Noises from individual rear seats

Topic number	LI91.12-P-057916
Version	2
Design group	91.12 Rear seats
Date	04-28-2014
Validity	Model series 222 with code 223 or 224
Reason for change	One operation item (item 5) added to Remedy
Reason for block

PIC_1.jpg:

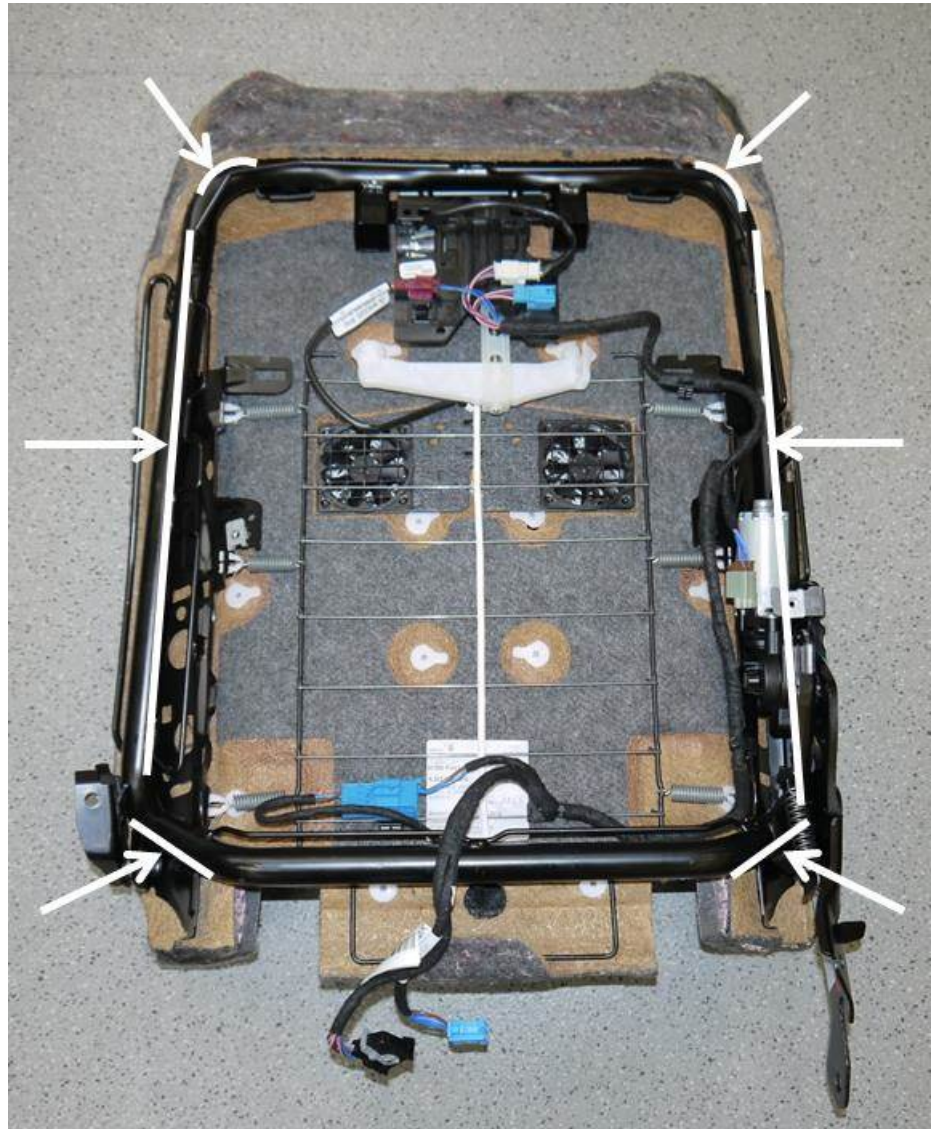
Noises can occur when sitting down or when adjusting the backrests of the individual rear seats

Unfavorable component tolerances.

1. Remove backrest
2. Remove backrest padding
3. Attach felt material to the backrest frame (see picture PIC_1)
 - At the lower radii
 - At the side frame elements
 - At the upper radii
4. Attach felt material to the rear of the rear backrest padding (not with SA code 406!) (see picture PIC_2)
 - Felt size 70x320 mm
5. Apply a care product to the seat cover and wheel well liner in the area of the contact surfaces between the individual rear seat backrests and the wheel well liner at the C-pillar
(see pictures PIC_3, PIC_4 and PIC_5)
6. Apply a care product to the seat covers in the area of the transition from the rear backrest to the center armrest
(see picture PIC_6)
